**SAFETY EVALUATION OF
PROPOSED TECHNICAL SPECIFICATION CHANGES ASSOCIATED WITH
PRESSURE-TEMPERATURE AND OVERPRESSURE PROTECTION SYSTEM
LIMITS FOR UP TO 13 EFFECTIVE FULL POWER YEARS**

NEW YORK POWER AUTHORITY
INDIAN POINT 3 NUCLEAR POWER PLANT
DOCKET NO. 50-286
DPR-64

**MARK-UP OF TECHNICAL SPECIFICATION PAGES ASSOCIATED WITH
AMENDMENT REQUEST FOR PROPOSED TECHNICAL SPECIFICATION CHANGES
ASSOCIATED WITH PRESSURE-TEMPERATURE AND OVERPRESSURE PROTECTION
SYSTEM LIMITS FOR UP TO 13 EFFECTIVE FULL POWER YEARS**

Figure 2.7
RCS Pressure Limitations for Hydrostatic Testing, 13 EFY

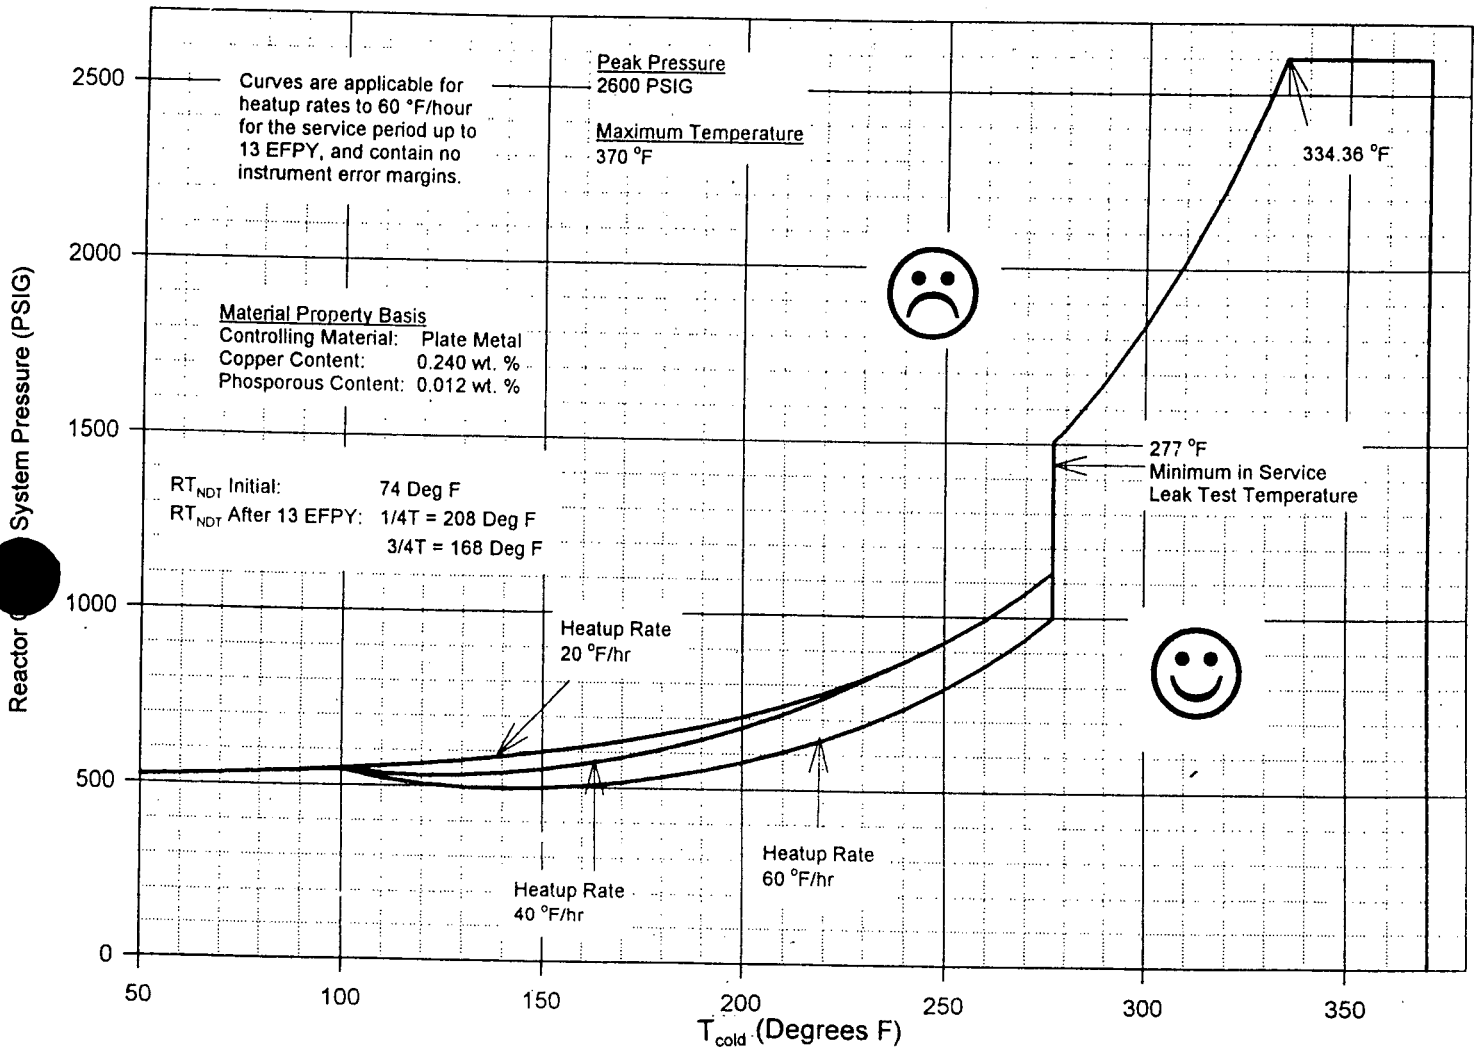
The OPS ~~arming enable~~ temperature of ~~332°F~~ permits the performance of an RCS hydrostatic test (see Fig. ~~4.3-1~~ **2.7 in the PTLR**) without activating the OPS.

The inservice leak test temperatures are shown on Figure ~~4.3-1~~ **2.7 of the PTLR.** The temperatures are calculated in accordance with ASME Code Section III, Appendix G. This Code requires that a safety factor of 1.5 times the stress intensity factor caused by pressure be applied to the calculation.

RT_{NDT} predictions for the applicable service period are shown on PTLR Figure 2.7, with the accompanying margins to safety limits.

The heatup limits specified ~~on the heatup curve, Figure 4.3-1 in~~ **Figure 2.7 of the PTLR**, must not be exceeded while the reactor coolant system is being heated to the inservice leak test temperature. For cooldown from the leak test temperature, the limitations of **PTLR Figure 3.1-2 2.2** must not be exceeded. ~~Figures 4.3-1 and 3.1-2 PTLR Figures 2.2 and 2.7~~ are recalculated periodically, using methods discussed in the Basis for Specification 3.1.B and results of surveillance specimens, as covered in Specification 4.2.
